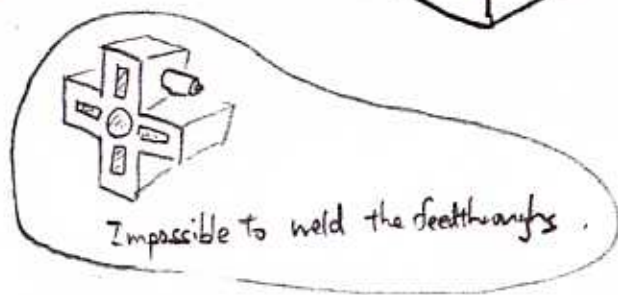
Impossible to weld the feedthroughs.
